Beaver Valley Power Station, Unit No. 1
Docket No. 50-334, License No. DPR-66
Response to Request for Additional Information - 2007 Steam Generator Tube
Inspections (TAC No. MD8392)

Response to Request for Additional Information, 2007 Steam Generator Tube
Inspections, Beaver Valley Power Station, Unit No. 1

Response to Request for Additional Information
2007 Steam Generator Tube Inspections
Beaver Valley Power Station, Unit No. 1
Page 1 of 5

Figure 1 – BVPS-1 Steam Generator Tubesheet Map

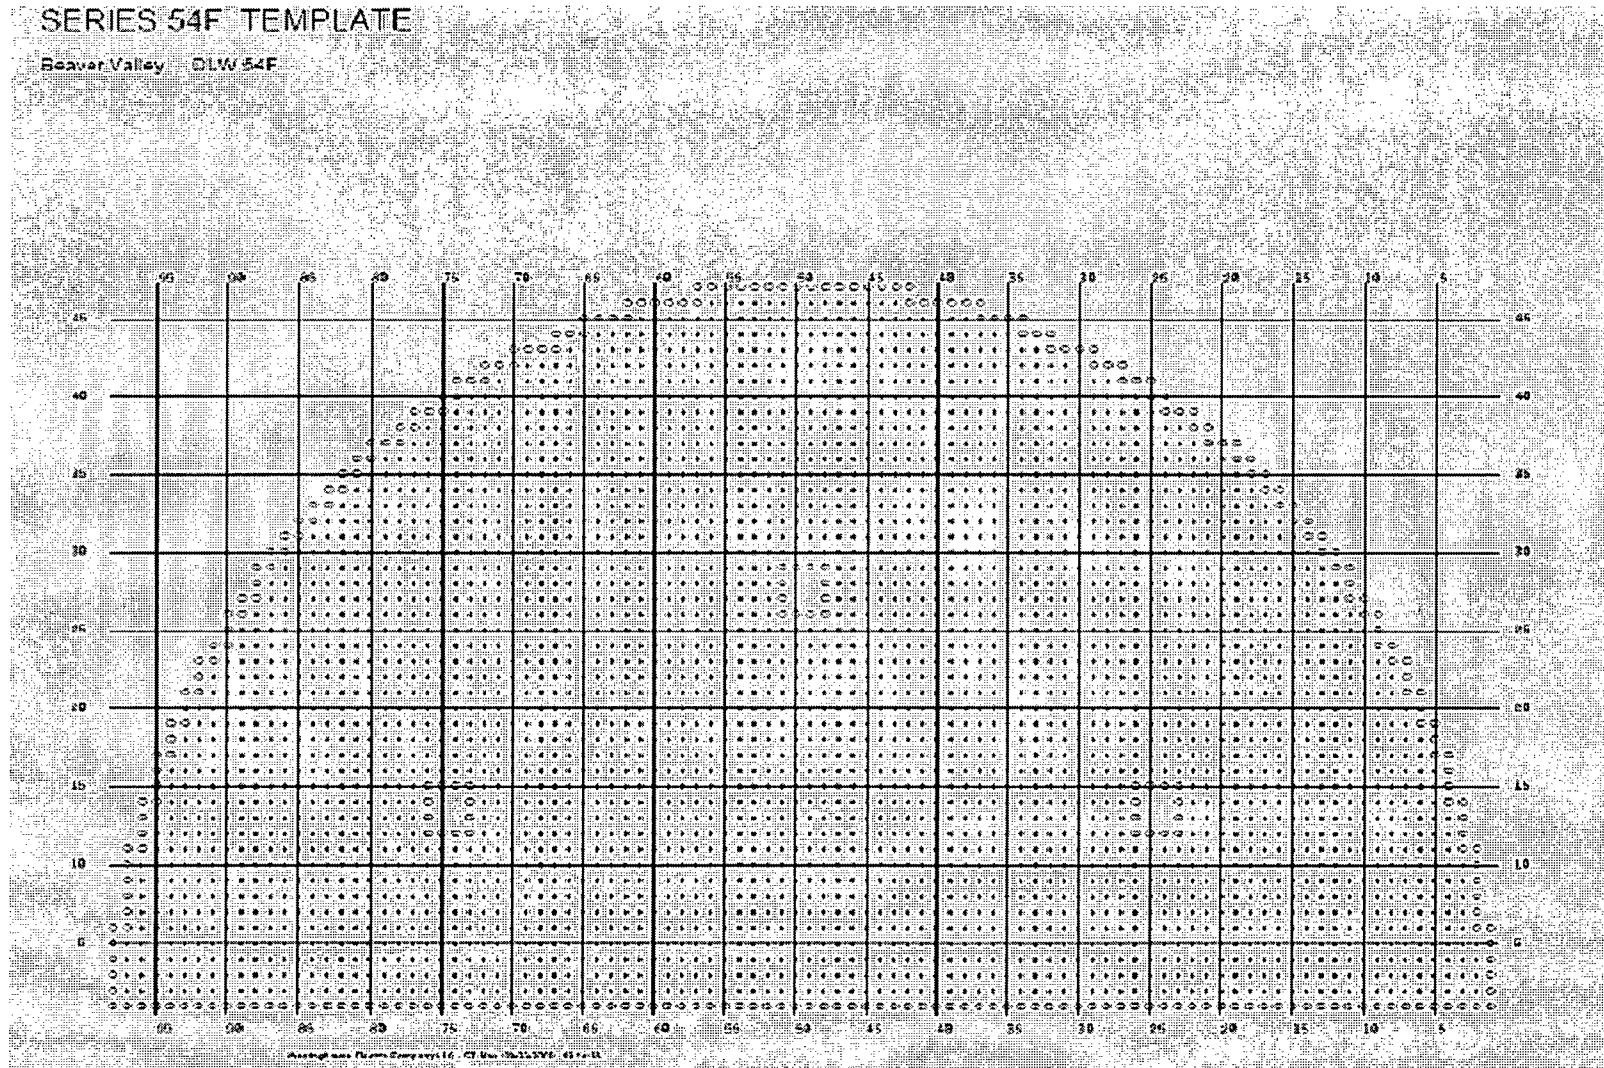
c. A tubesheet map

A tubesheet map is provided in Figure 1.

Figure 2 – BVPS-1 Steam Generator Support Plate Naming Convention

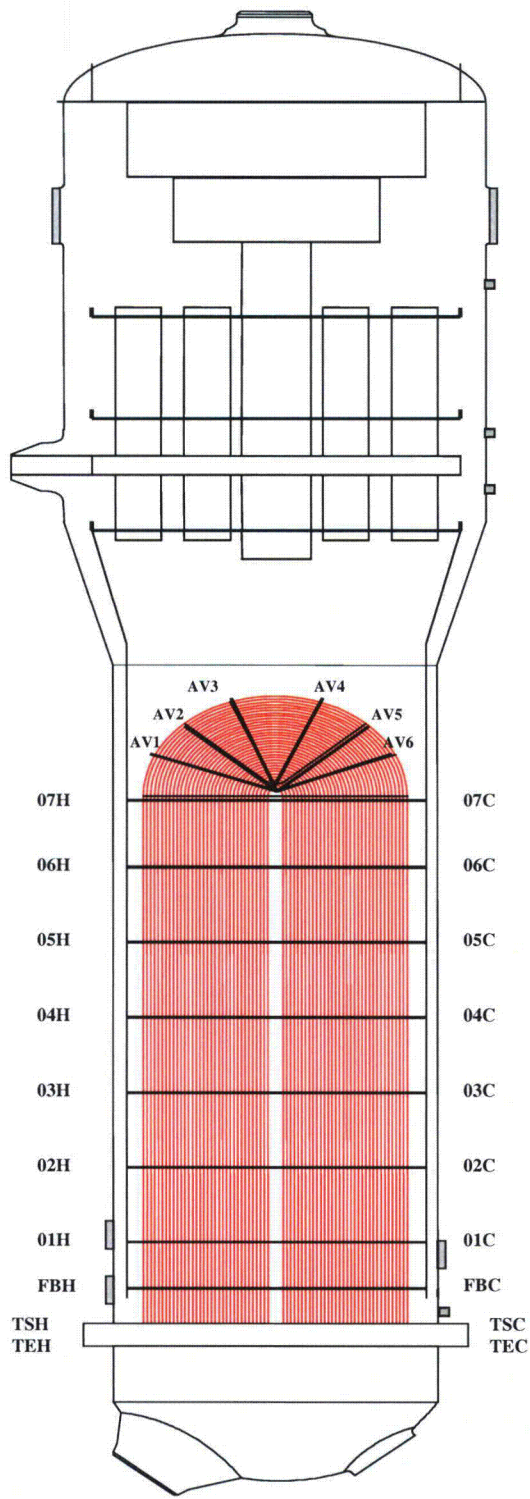
d. The SG tube support plate naming convention used

The SG tube support plate naming convention is illustrated in Figure 2.

Figure 3 – BVPS-1 Steam Generator Flow Distribution Baffle

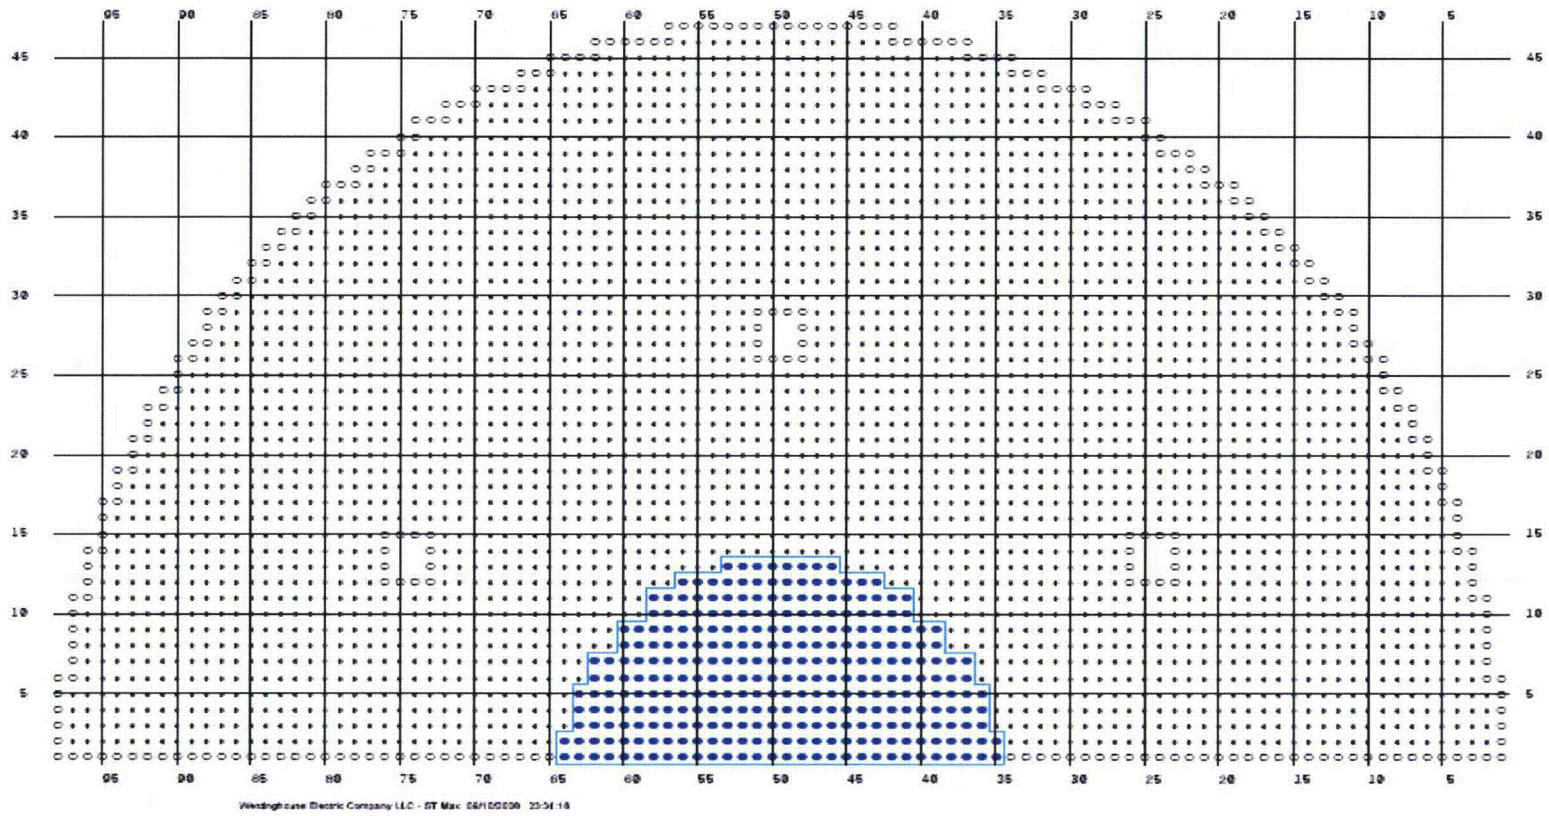
f. Whether the SGs have a flow distribution baffle plate, and if so, a description of the plate

The Model 54F design includes a flow distribution baffle (Labeled "FBH" and "FBC" on Figure 2) located between the top of tubesheet and first tube support plate. The flow distribution baffle (FDB) is designed to minimize the number of tubes exposed to low velocity flow in the vicinity of the tubeplate. The flow distribution baffle, fabricated from ASME SA-240, Type 405 stainless steel, has octafoil shaped broached tube holes. The effective annular flow area between

the tube outside diameter and the effective hole inside diameter is less in the case of the flow distribution baffle than for the tube support plates. Also, the center portion of the flow distribution baffle is cut out as indicated in Figure 3. This flow distribution baffle design controls the cross-flow velocity so that the low velocity region (and sludge deposition zone) is located at the center of the tube bundle, near the blowdown intake.
